## Amended map of the proposed modifications

Coastal Access - Isle of Wight - Natural England's Proposals  
Report IOW 4: Binnel Bay to Chilton Chine

Map IOW 4h Shepherd's Chine to Brighstone Bay- IOW-4-SO87 to IOW-4-SO88

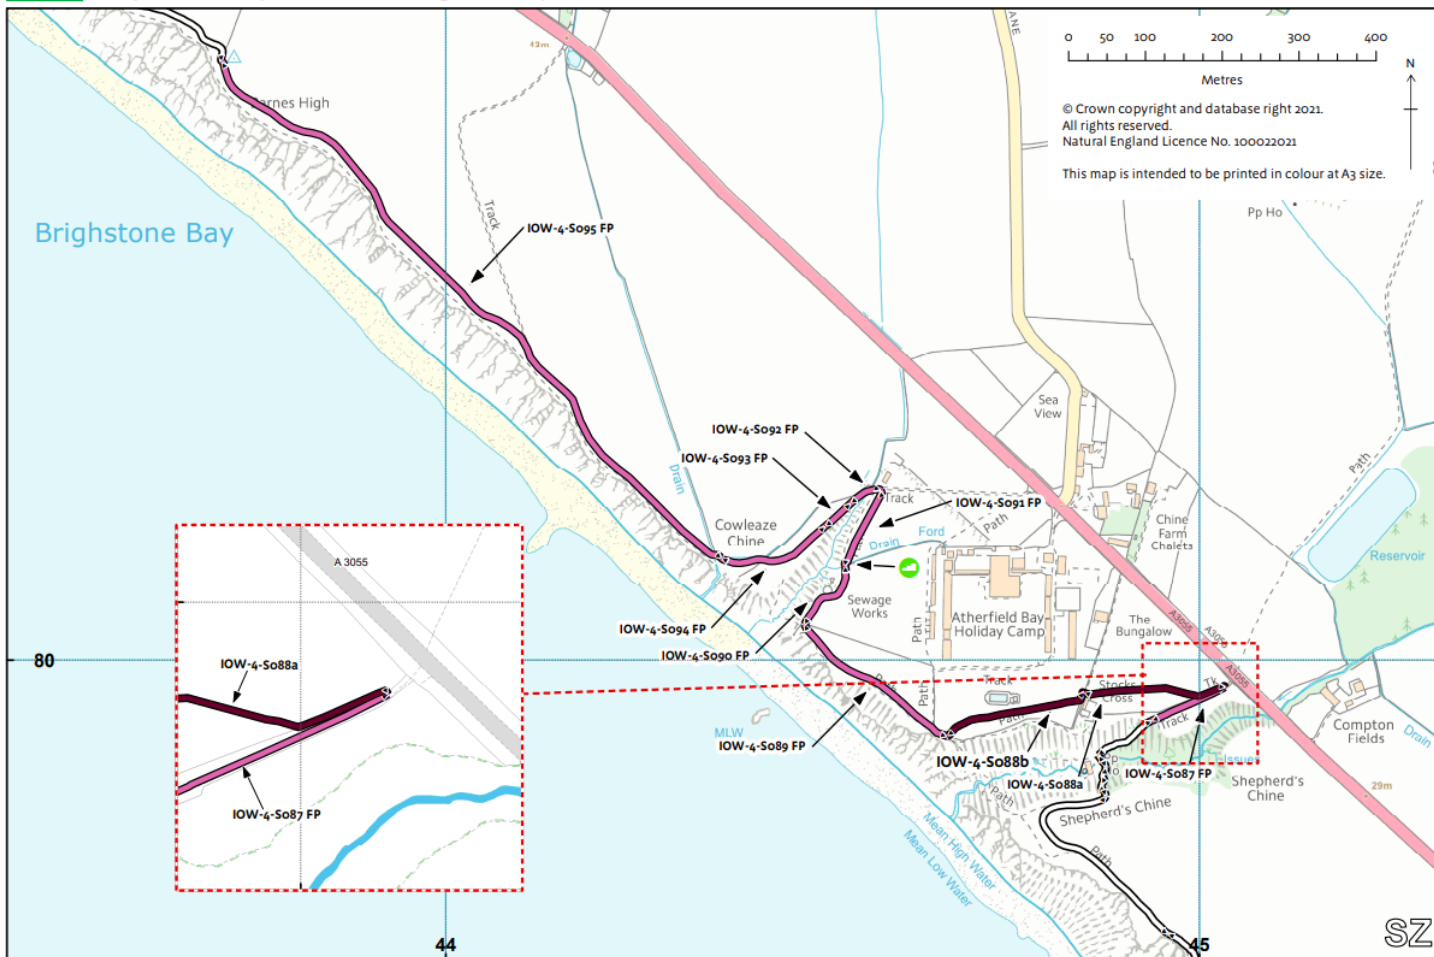
4. Revised Map IOW 4h and table showing two modifications to the route at IOW-4-S087 to IOW-4-S088b. The first modification is to realign the junction of IOW-4-S087 and IOW-4-S088a 15 metres further back from the road to minimise use of a field gate which is used to contain livestock. The second modification is to realign IOW-4-S088b to a previously agreed route set out in the planning application agreement for the adjacent development at Atherfield Bay Holiday Camp.

Map IOW 4j Marsh Chine to Isle of Wight Pearl- IOW-4-S109 to IOW-4-S114

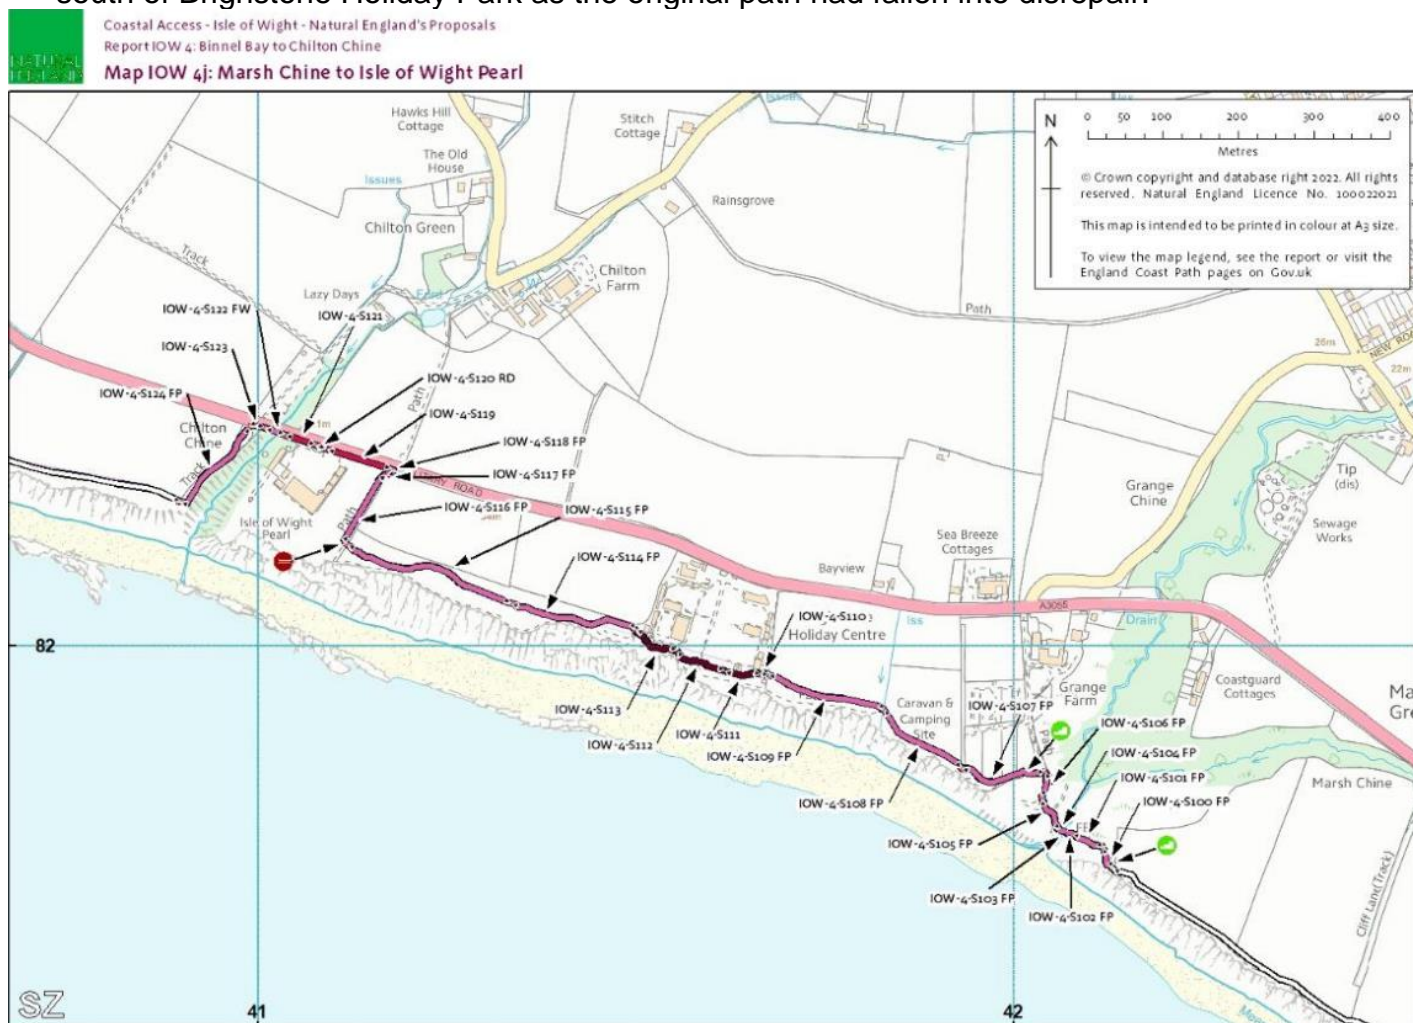
- Revised Map IOW 4j and table show a modification to the route at IOW-4-S110 to IOW-4-S113 as a result of further discussions with the landowners to realign the permissive path to the south of Brighstone Holiday Park as the original path had fallen into disrepair.

Map IOW 4d Gore Cliff to The Saeter- IOW-4-S058 to IOW-4-S059

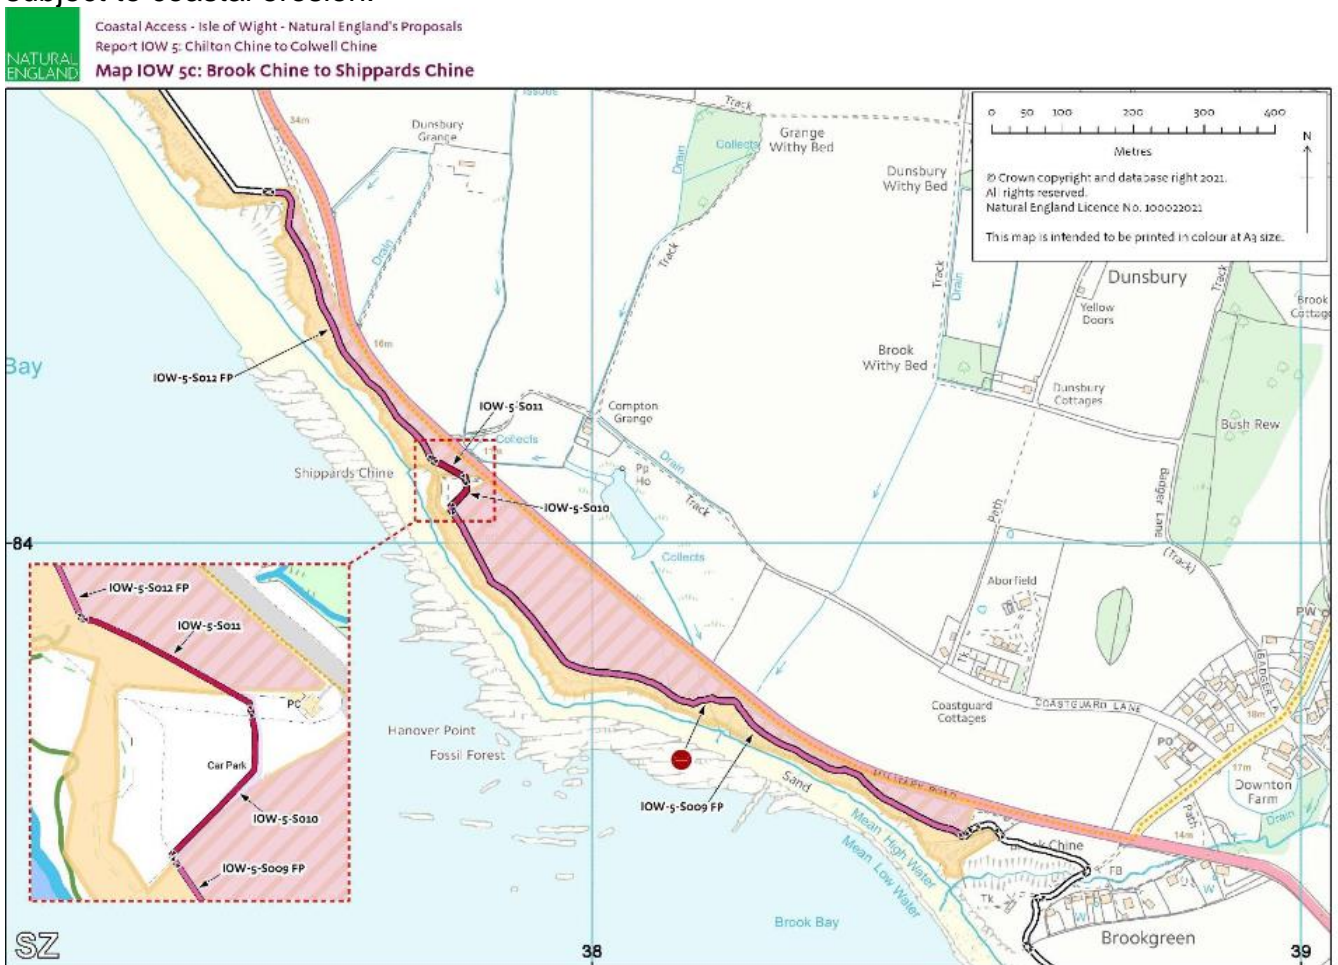
6. Revised Map IOW 4d and table showing modification to the route IOW-4-S048 through to IOW-4-S060. This modification is to realign the route so that users don't pass through the Blackgang overflow car park which can become busy during certain points of the year.

Map IOW 5c Brook Chine to Shippards Chine- IOW-5-SO10 to IOW-5-SO11

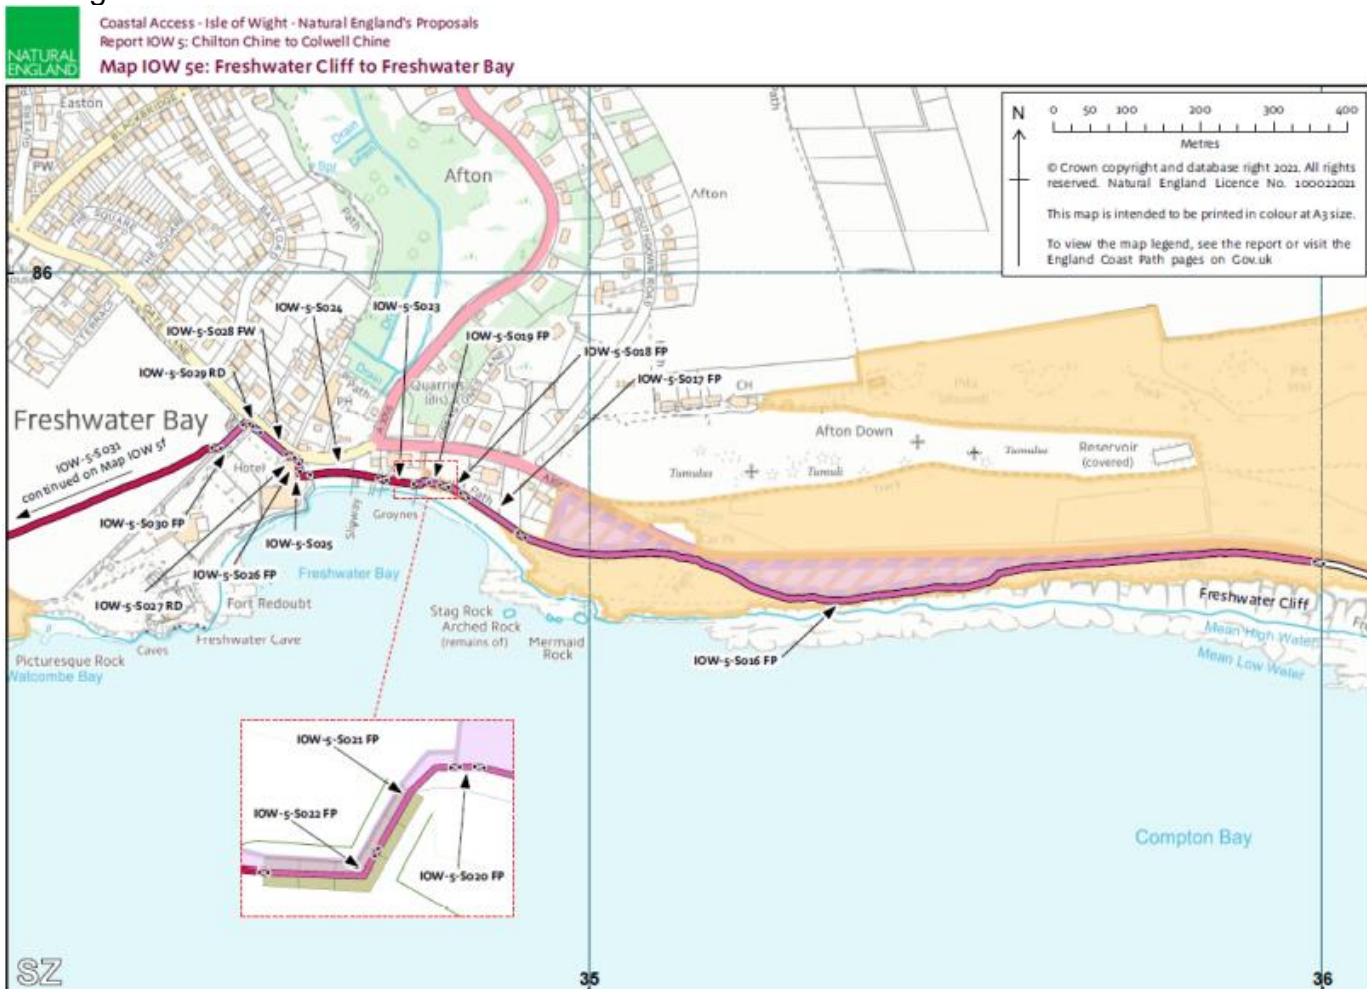
- Revised Map IOW 5C and table showing modification to the route IOW-5-S010 to realign the path through the National Trust car park. This is due to the path seaward of the car park being subject to coastal erosion.
